SEWAGE DISPOSAL SYSTEM

HOWARD COUNTY HEALTH DEPARTMENT
BUREAU OF ENVIRONMENTAL HEALTH
410-313-2640

P 515004
A REPAIR
ISSUE DATE 3/26/01
APPROVAL DATE 3/27/01

UBDIVISION Warfield Estates LOT NUMBER 11 ADDRESS 14509 MacClintock Drive

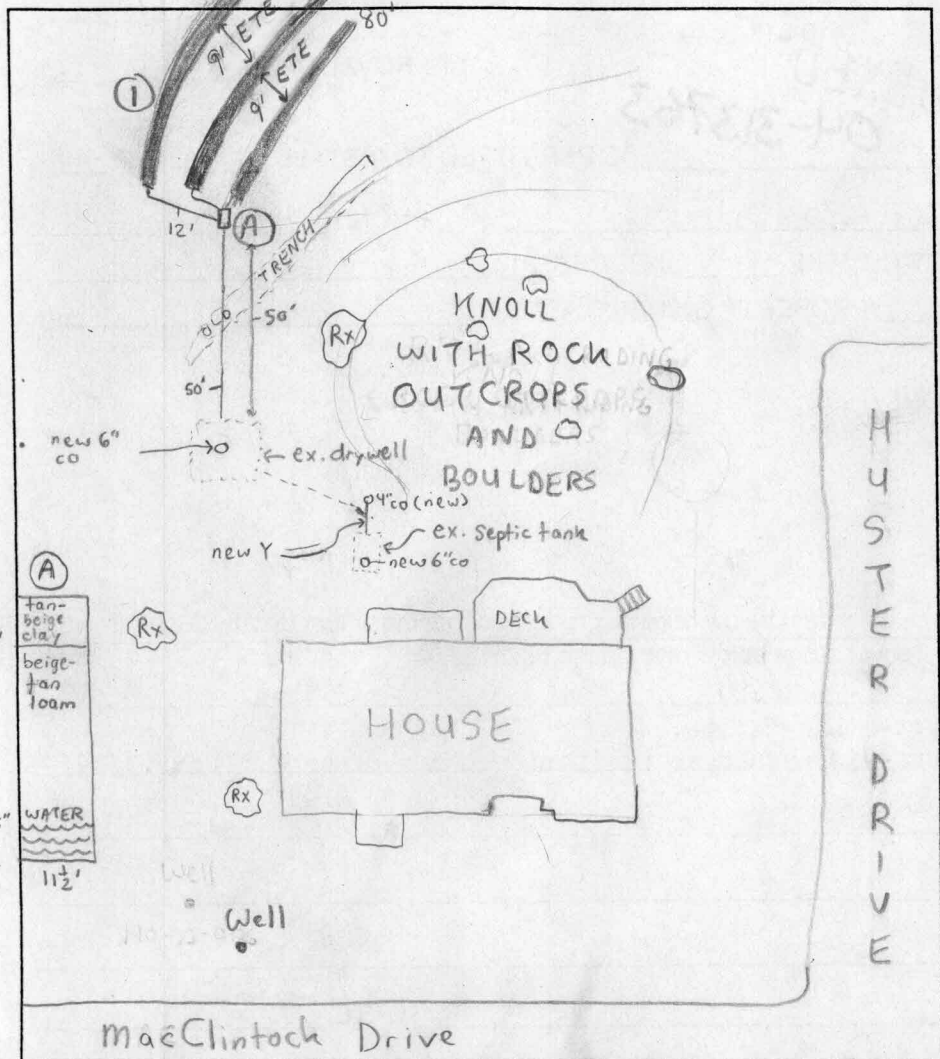
LOCATION:
REPAIR - PURPOSE - Existing septic system has failed.
Call for inspection when ground is opened so sanitarian can recommend repair. 3/26/01
Install new distribution box off of ex. drywell and run 3-80'
trenches on contour.
